# DOCUMENT 00 90 10

## ADDENDUM No. 1

- A. The Construction Contract is known as North Street, Harrisville to Wall.
- B. Date of this Addendum: February 14, 2023.

North Street- Harrisville to Wall

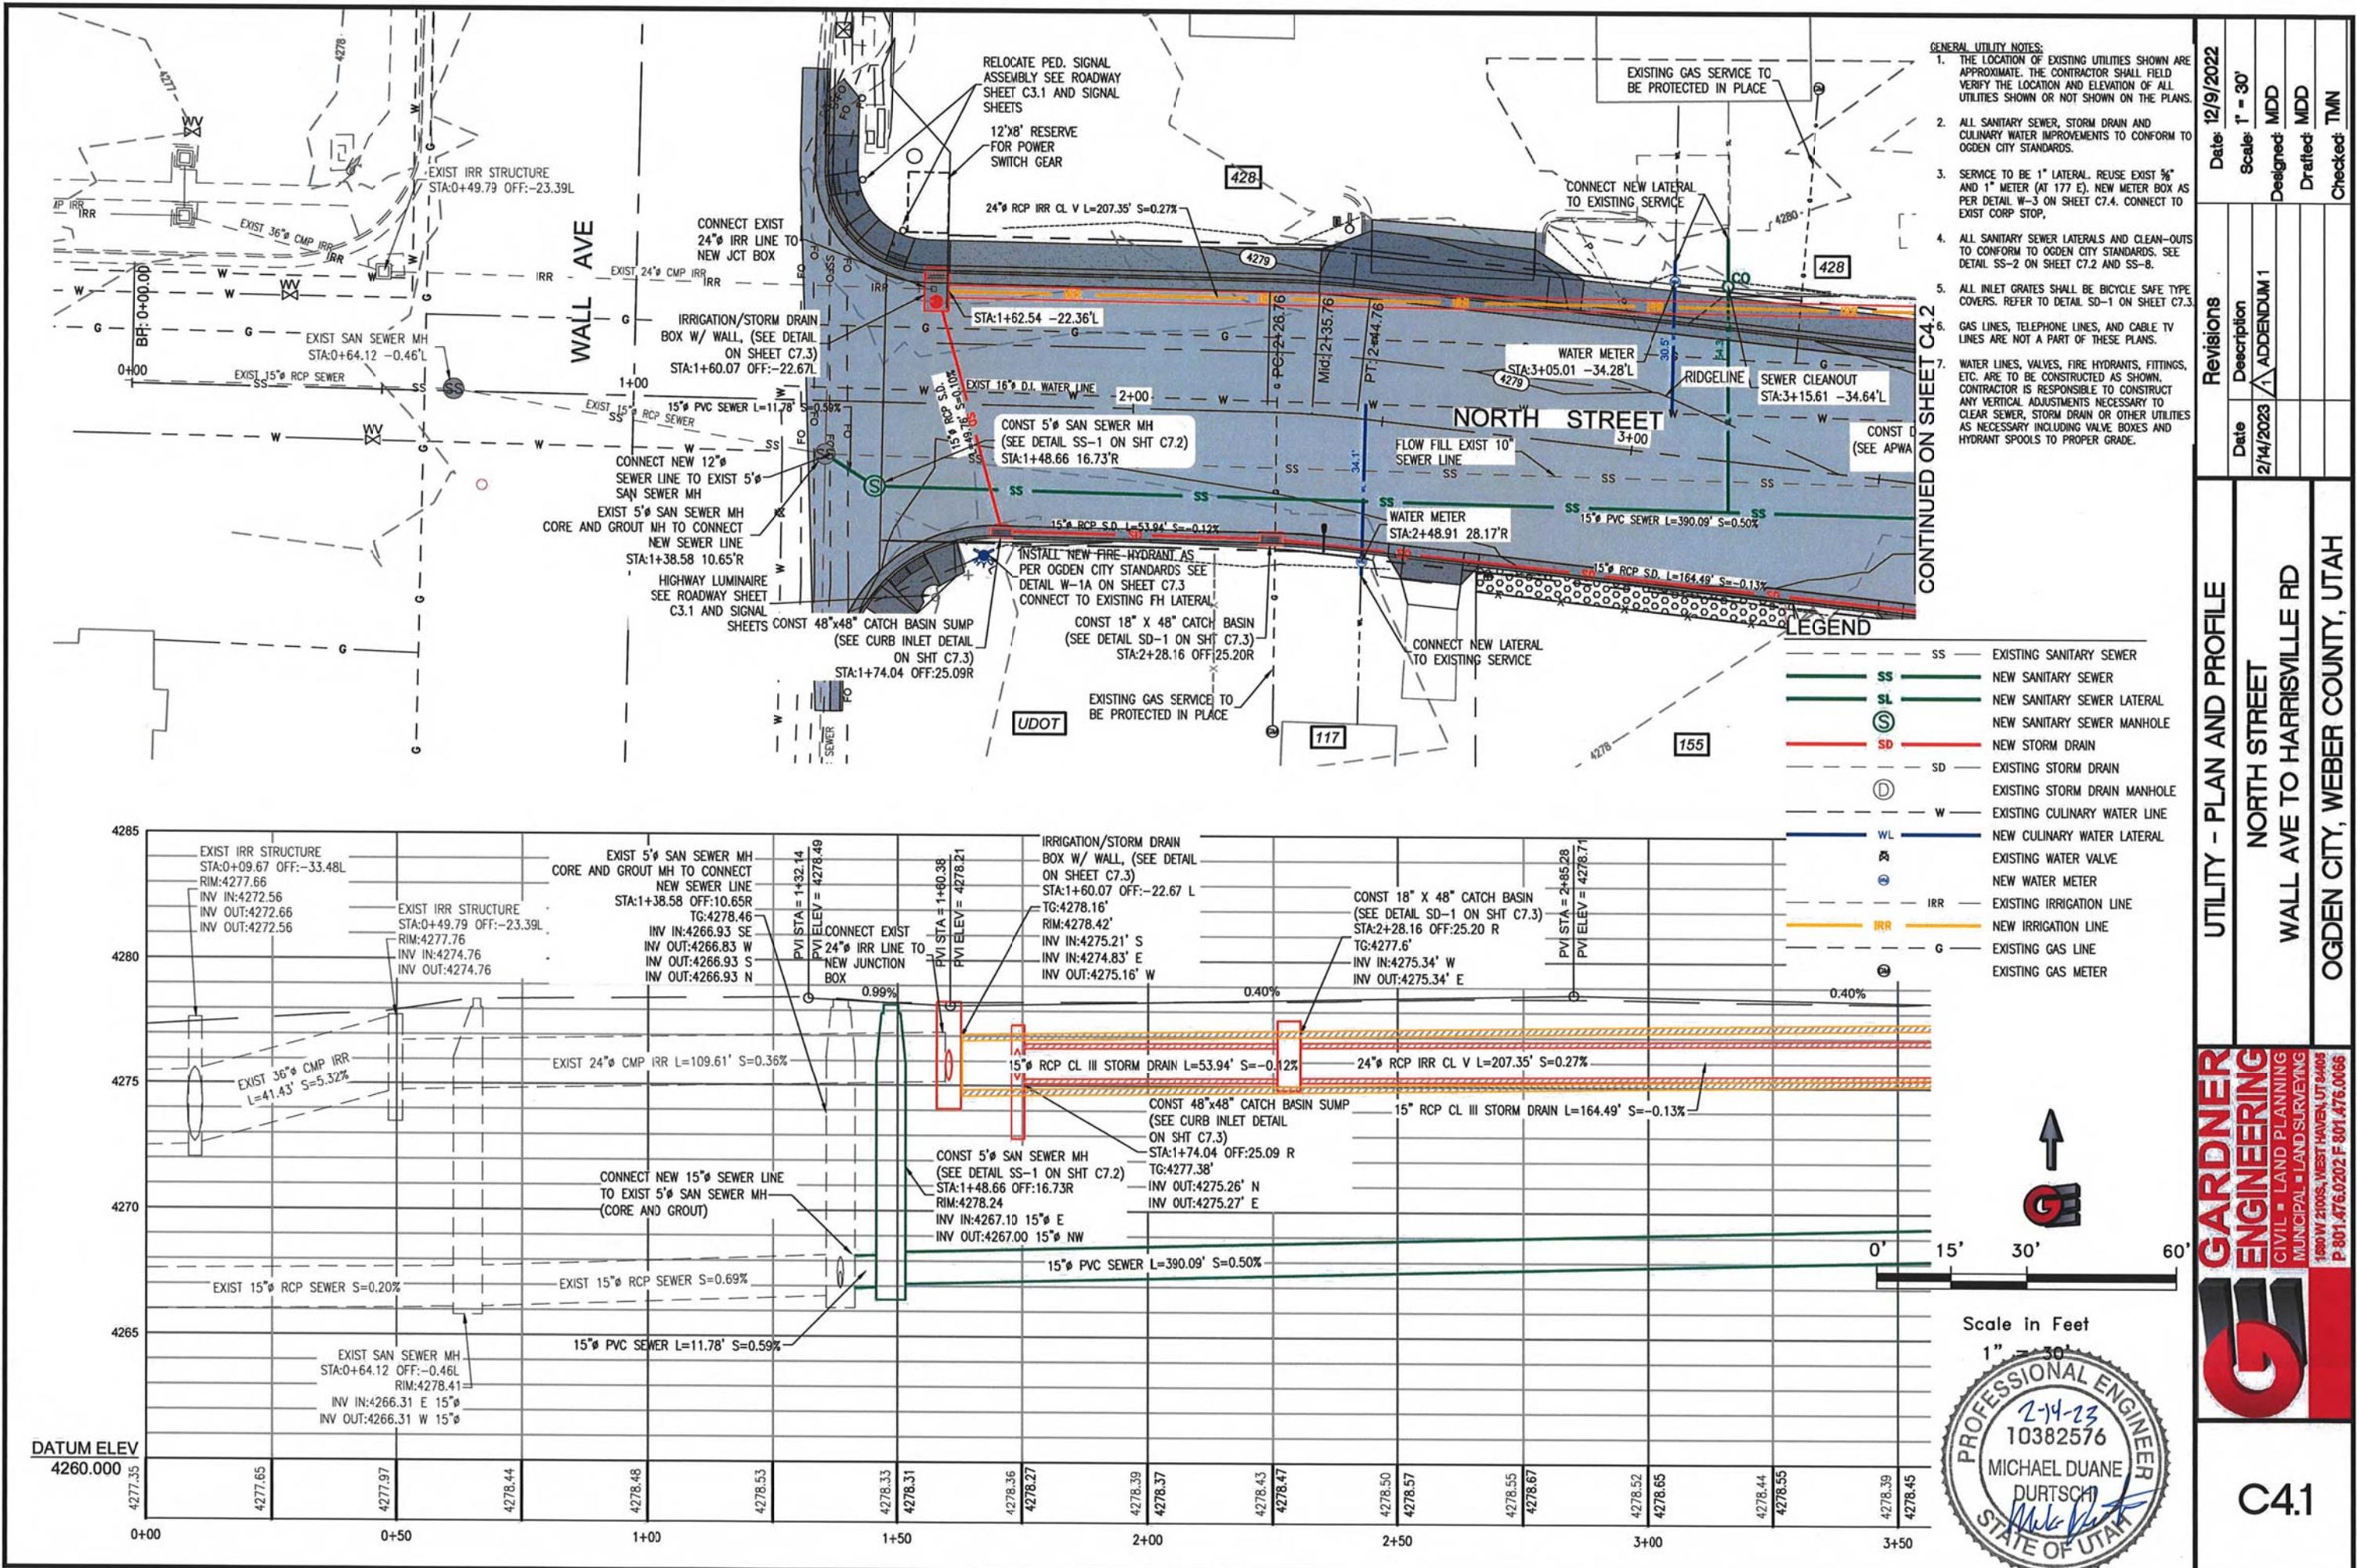
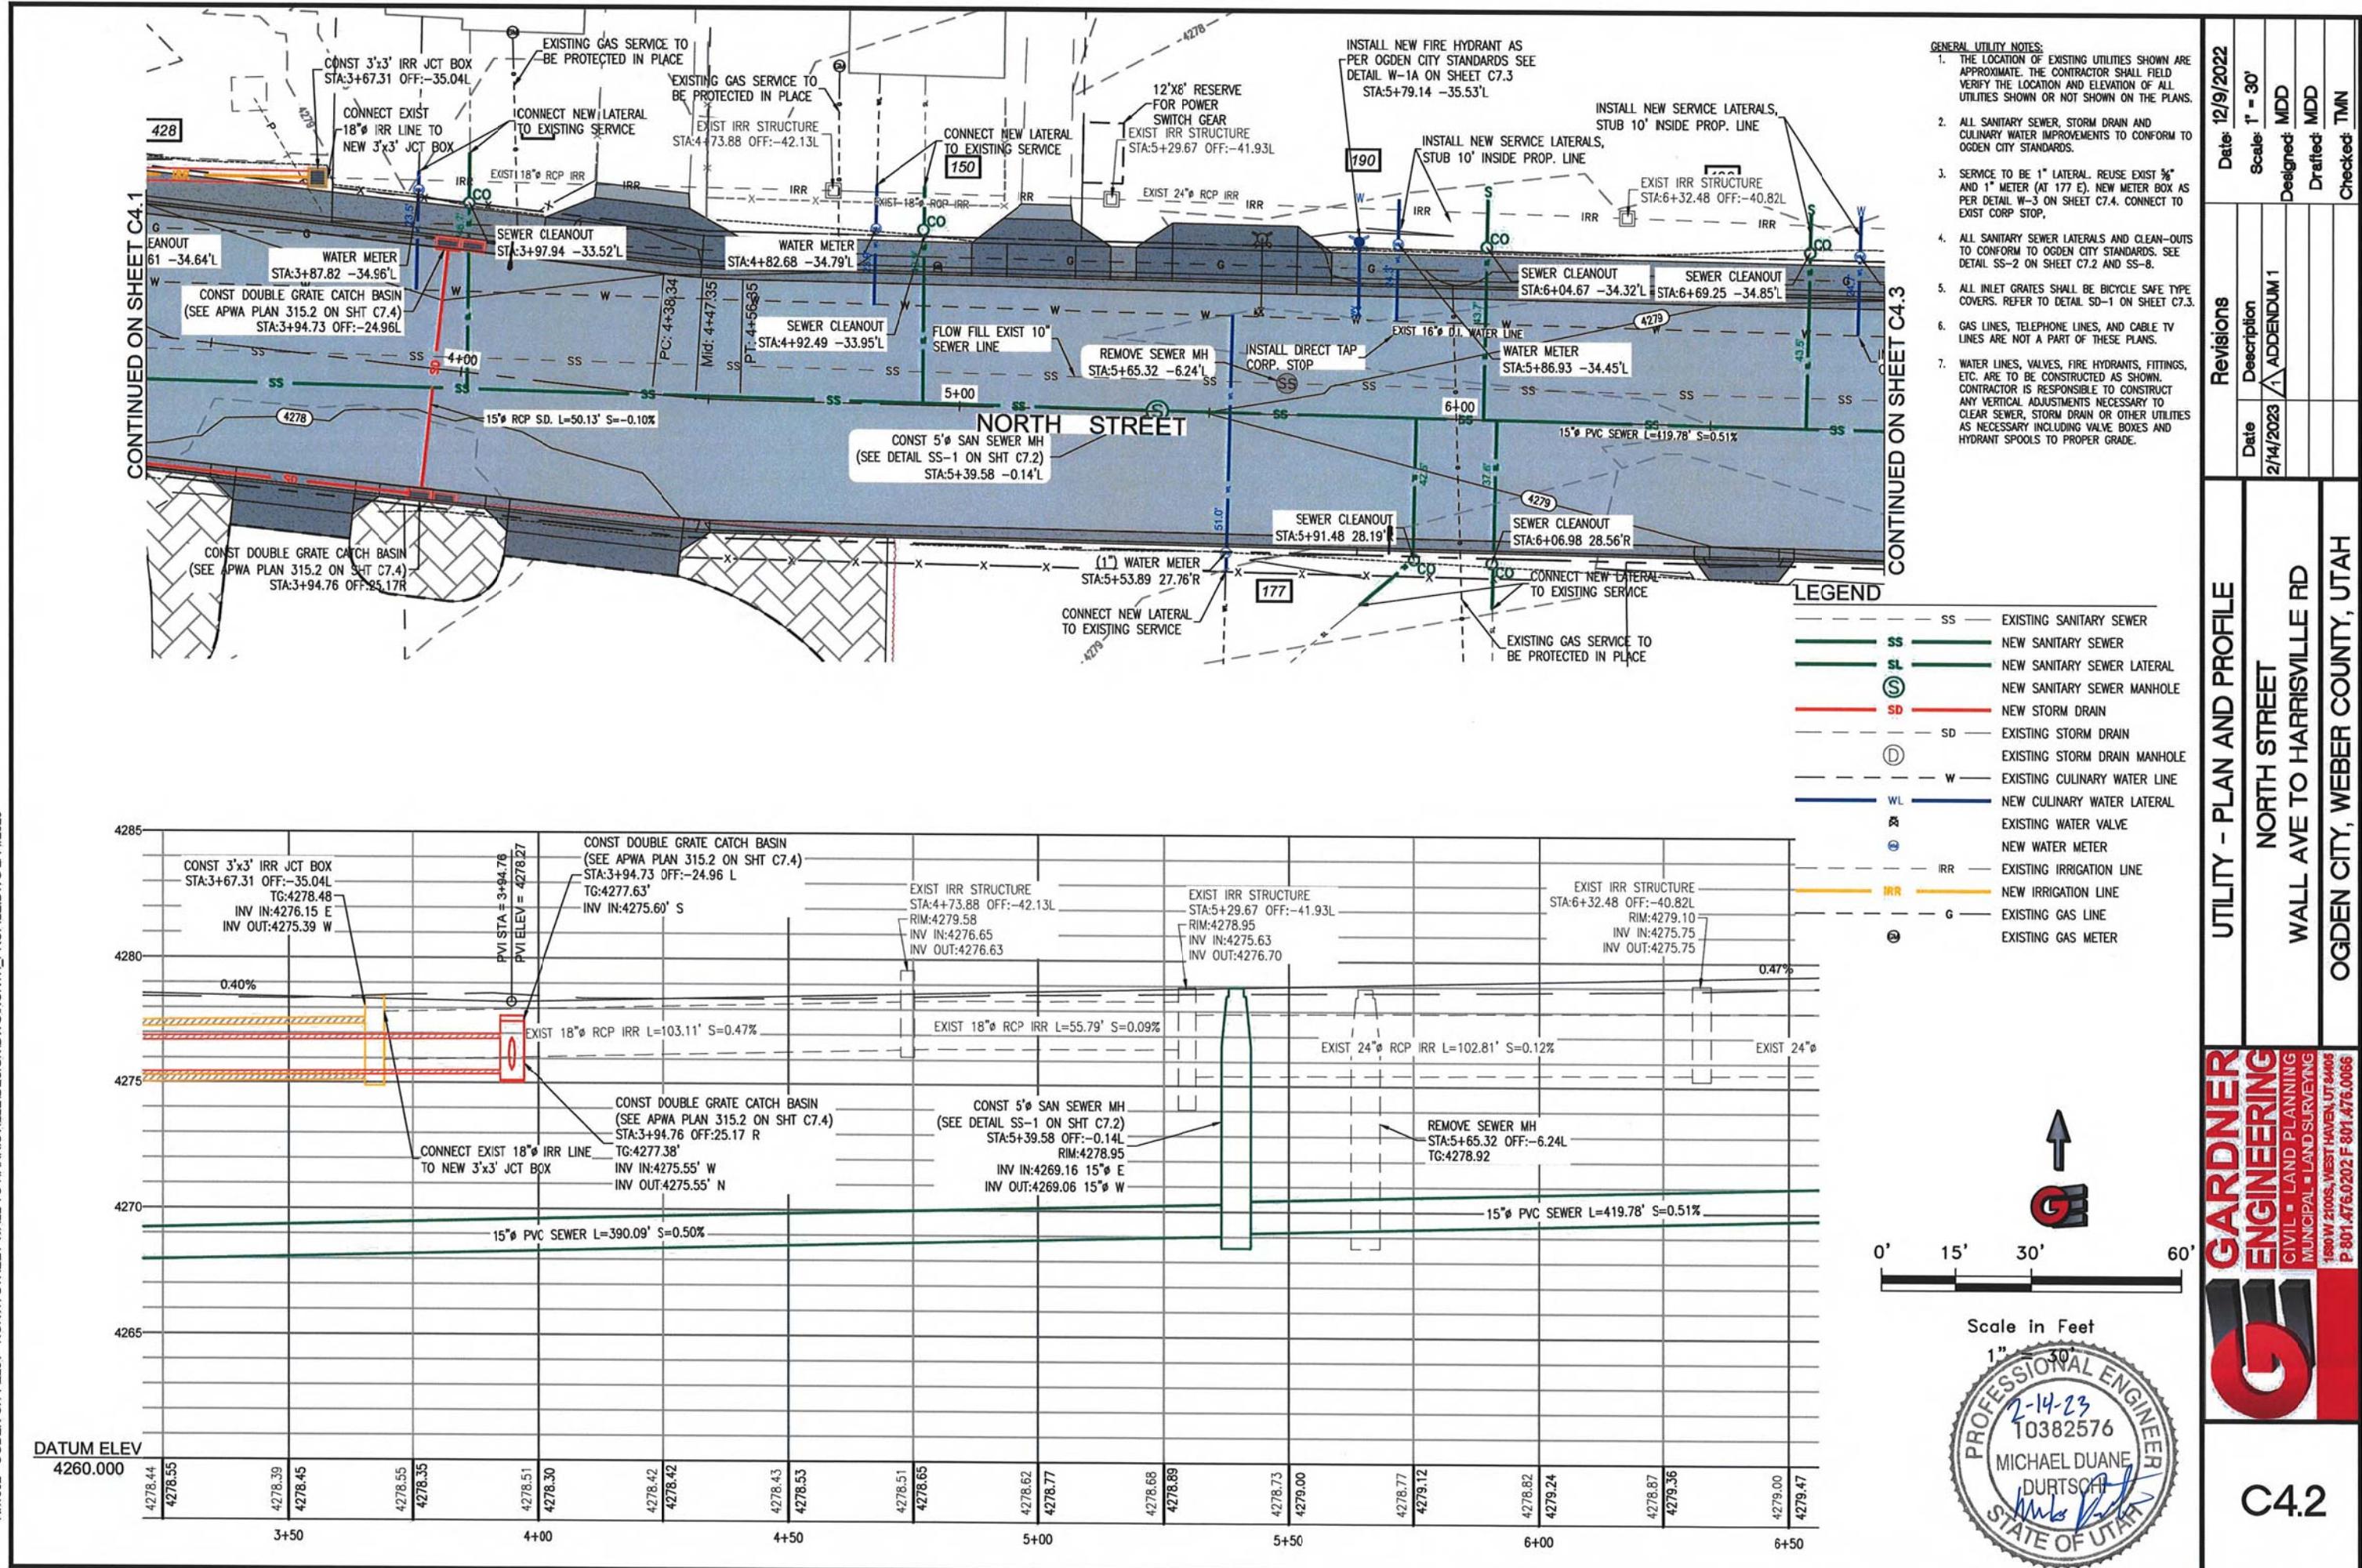
- ii. Sidewalk depth and UTBC depth changed from “4” to “6”.
- E. See Sheets C3.1-C3.2 and C5.1-C5.2 for the following updated items:
  - i. Lay out change at DRIVEWAY ENTRANCES TO BUDDHIST CHURCH.

- ii. Location of proposed fence to be done by others along Church frontage.
  - iii. Relocate Sign Location.
  - iv. Added note “FUTURE LANDSCAPING, DONE BY OTHERS, TO MEET WATER WISE LANDSCAPING PER CITY CODES 15-4-5.E, 15-13-16, AND 15-28.”

- v. Updated Buddhist Church Site Restoration note to add the following “SITE RESTORATION BUDDHIST CHURCH 6:1 TAPER -ROCK 4" DEPTH (15.6 CY) GEOTEXTILE FABRIC (1260 SF)”
